**PLANNING AND ZONING COMMISSION OF JEFFERSON COUNTY, MISSOURI
NOTICE OF MEETING**

PETITION NUMBER: PR124027

APPLICATION (PROJECT) NAME: HILLCREST

PETITION NUMBER: PM24032

EXHIBIT B - DEVELOPMENT PLAN

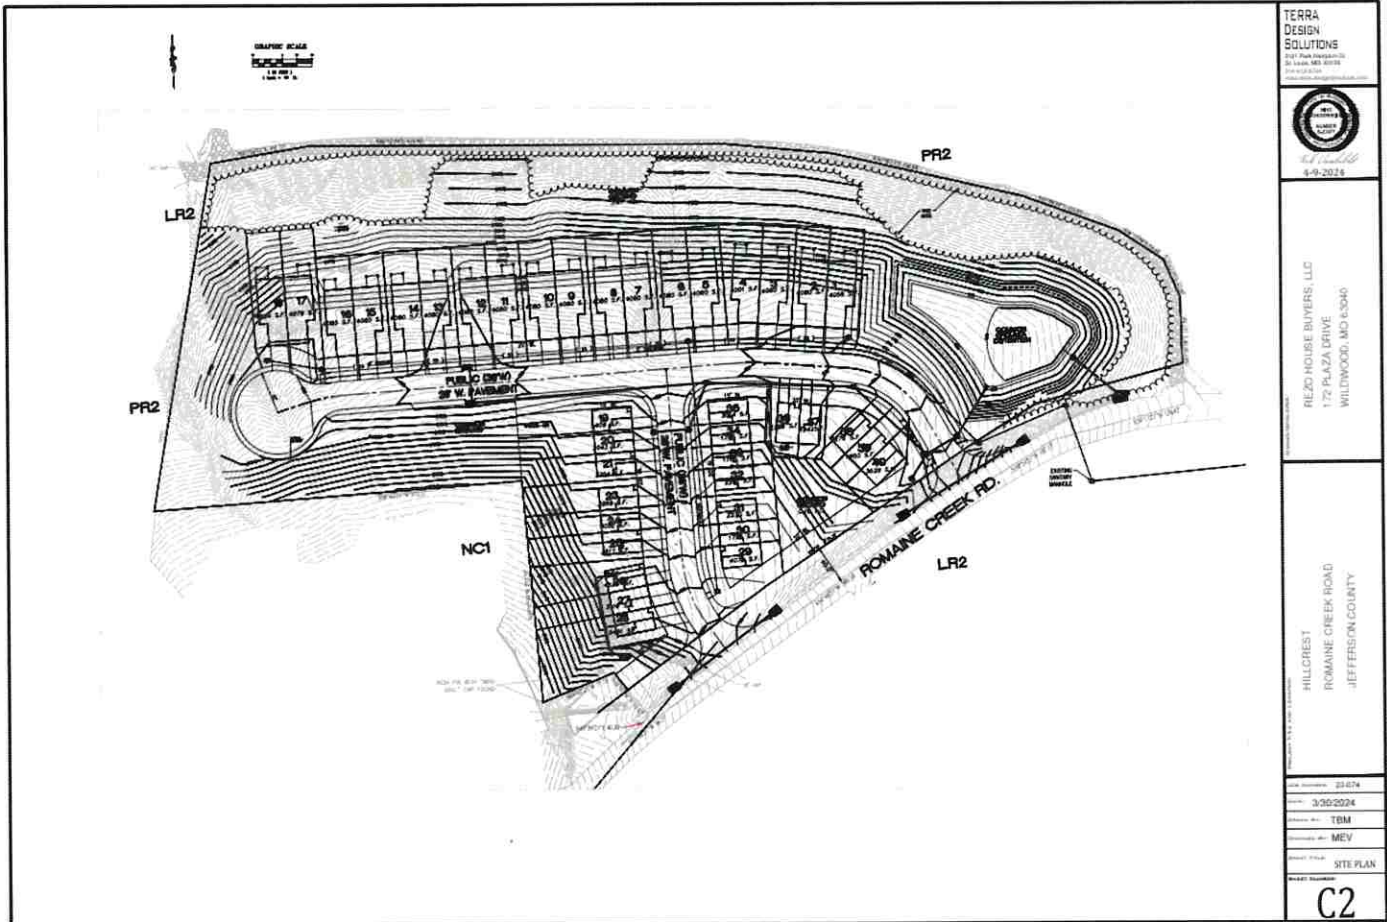
The proposed Development Plan shows two full access points. It is unclear if they meet the County's standards on ingress and egress. The two access points use county-maintained road Romaine Creek Road to service the proposed units. The units fall well under the requirements for additional access points (100 or more) from a county-maintained road.

Relief from 400.1670— Minimum building setbacks: The petitioner is requesting to reduce the front setbacks from 25' to 20' and the side setbacks from 6' to 5'. The lots that are being created are brand new lots. There are some topographical challenges on the site, however there appears to ample room, given the amount of undisturbed common ground to push the houses back another 5' feet and allow for another foot of buffer on the sides that adjoin other structures. There have been other duplex developments in the county (most recently at Amberleigh Woods in 2022) that did not require a reduction in the setbacks.

Proposed zone district on cover sheet calls out R-07 should state PR1

Street width shows 28' pavement within 34' ROW with curbs which will allow parking on one side. No parking signs will be required on one side of street

Required 125' offset is not met with opposite driveways on Romain Creek Rd.

⇒ Staff recommends **Denial** of the requested modification to Section 400.1670—Minimum Building Setback Requirements.

EXHIBIT B - DEVELOPMENT PLAN

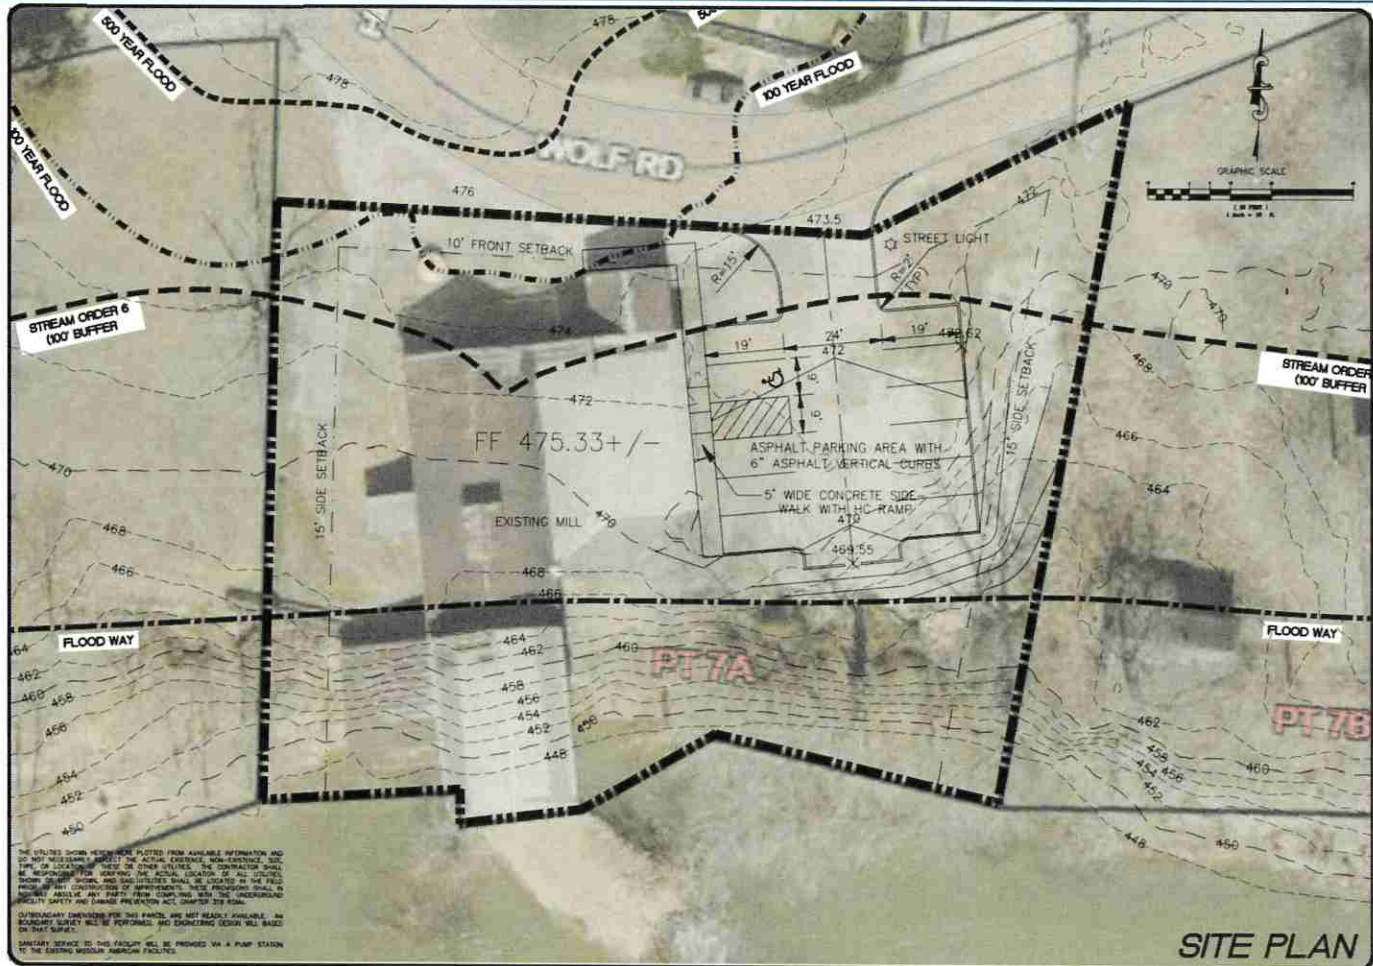
- The petitioner has requested relief from Section 400.4050—Vehicle Parking by Use
The petitioner is requesting relief from the parking requirements. The UDO would require a total of 27 spaces and the petitioner is requesting to provide 11. The petitioner has provided information that the museum will only employ 3 people. The additional parking is in an incredibly sensitive area that would also prove to be challenging and detrimental to the floodway and stream order issues the property faces. The Planning Division does not see any issue with reducing the number of parking spots given the low traffic and environmentally sensitive area of the property. However, given the fairly modest parking that will be installed, the lot will not be able to accommodate events or gatherings that would require more than 11 parking spots. Those types of events shall not be held at the site.

Modification request for buffer strip of the Stream Order 6 referenced below.

Show limits of the floodway.

Show the limits and the elevation(s) of the 100-year floodplain.

EXHIBIT A - PRELIMINARY PLAT

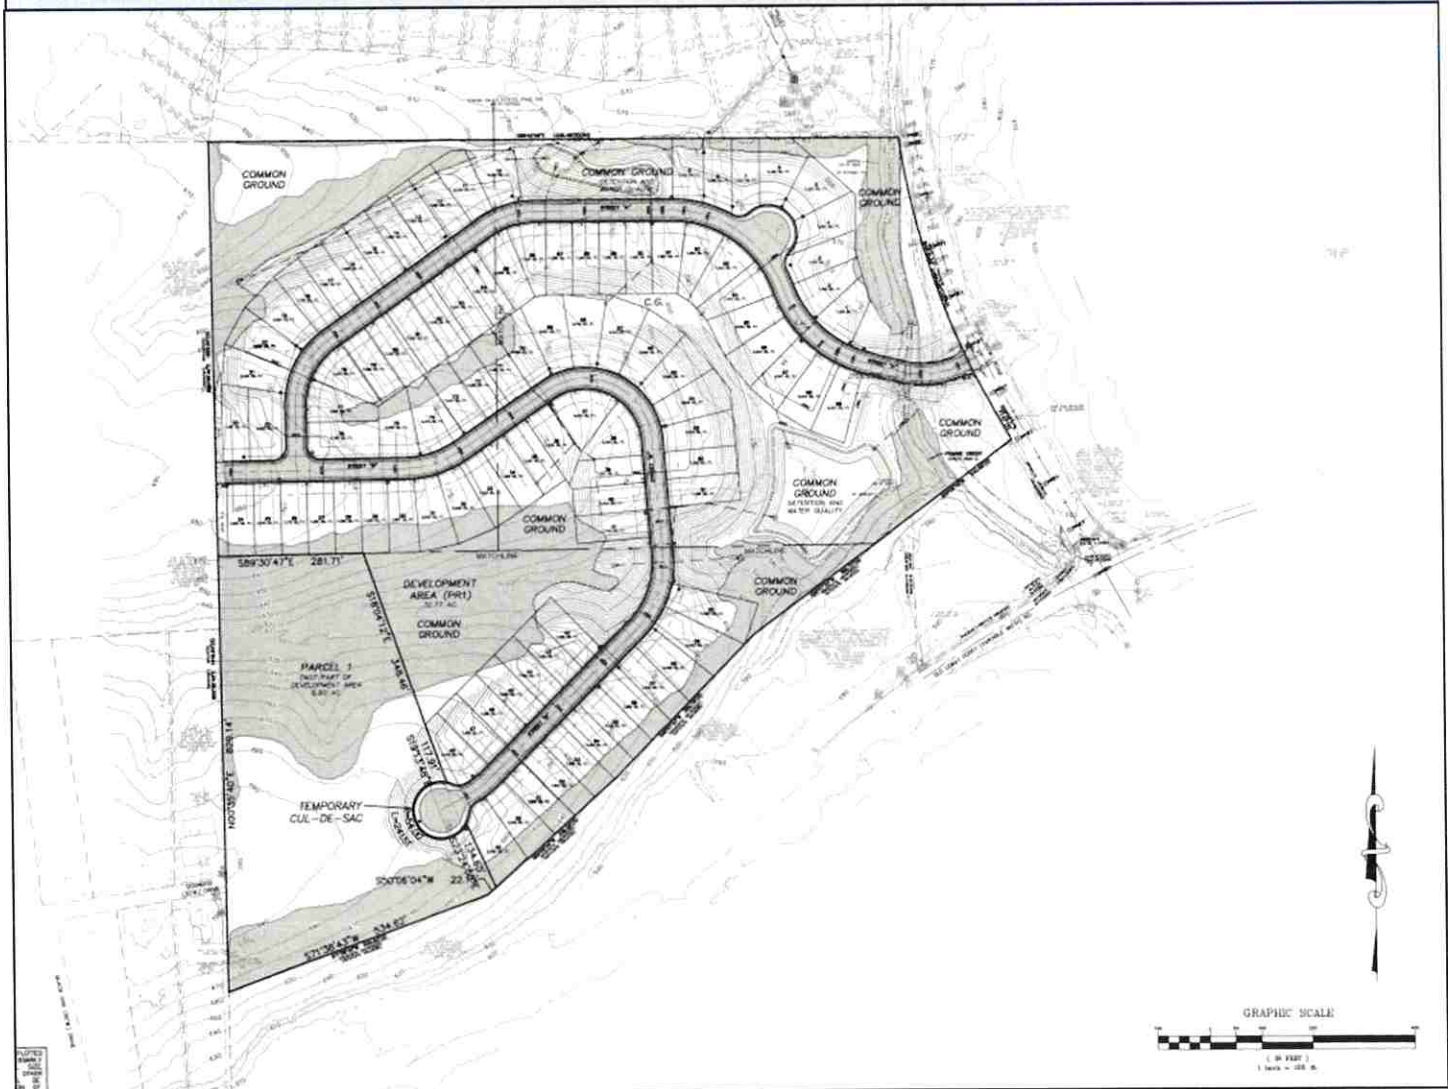
- Provide existing 5' contours per USGS or County datum.
- If development of lots is proposed on parcel 1 in future, a second point of access will be required.

- The street width provided only allows for parking on one side. "No Parking" signs will be required on one side of all streets.
- Streets shall not exceed 14% grades, 100' horizontal radii, K=20, 0' tangents, and 1500' block length.
- If the block length exceeds 1500' a brow, cul-de-sac, or turn around will be required.
- Cul-de-sacs must provide 50'R at ROW and 39' at back of curb.
- Proposed cul-de-sac at the end of "Street B" is called out as temporary. This cul-de-sac is required to be constructed as permanent.
- The corner clearance sight triangle is 35' along ROW at intersections (clear height 3'-10'). No obstructions in the sight triangle to be placed in the street ROW.
